UNITED STATES PATENT AND TRADEMARK OFFICE

APPLICATION NO.	FILING DATE	FIRST NAMED INVENTOR	ATTORNEY DOCKET NO.	CONFIRMATION NO.
10/042,567	11/20/2001	Roger C. Williams	BIWLOWF	6838

Office Action Summary

DETAILED ACTION

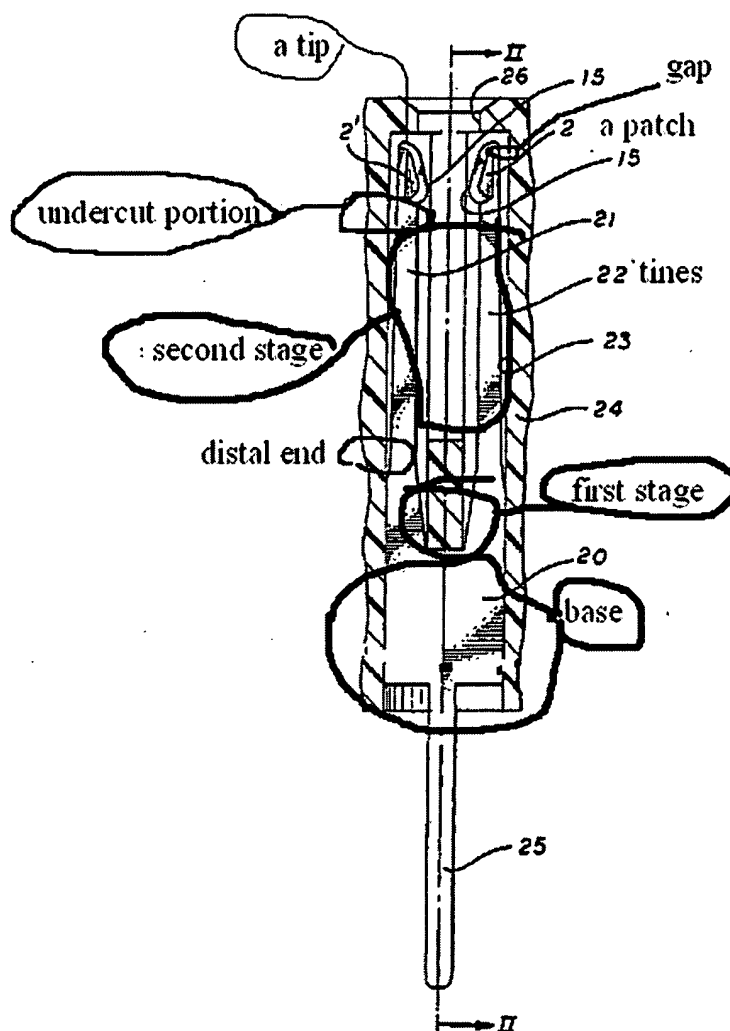
-- In reference to Claim(s) 3, Frommer shows (see examiner's figure) providing at each of the plurality of tines 22 first stage proximate a socket contact 24 having a first inner diameter disposed at one end thereof and which extends therefrom a distal end and where a second stage is

-- In reference to Claim(s) 5, Frommer shows (see examiner's figure) each of the tines 22 includes a first stage and a second stage, the first stage having a first wall thickness that is thicker than a second wall thickness of the second stage that is disposed proximate to the first stage and which extends therefrom toward a tip of each tine.

-- In reference to Claim(s) 6, Frommer shows an undercut portion (see examiner's figure) in each of the tines a predetermined distance from the tip.

-- In reference to Claim(s) 7, Frommer shows (see examiner's figure) the undercut portion extends to the first stage.

-- In reference to Claim(s) 8, Frommer shows (see examiner's figure) each of the tines includes a patch of material that is adapted to contact a pin, the patch being disposed intermediate the tip and the undercut portion.

-- In reference to Claim(s) 9, Frommer shows (see examiner's figure) the patch of material includes a greater thickness of material than the undercut portion.

-- In reference to Claim(s) 13, Frommer shows each of the plurality of tines 22 is machined wherein a tip (see examiner's figure) of each of the plurality of tines is normally disposed closer a center of the socket when the socket is not mated with a pin than second end (near the undercut portion detailed in the examiner's figure) of each the plurality of tines that disposed distally from the tip.

-- In reference to Claim(s) 14, Frommer shows (see examiner's figure) each of the plurality of tines have curved portions (at the patch shown in the examiner's figure)).
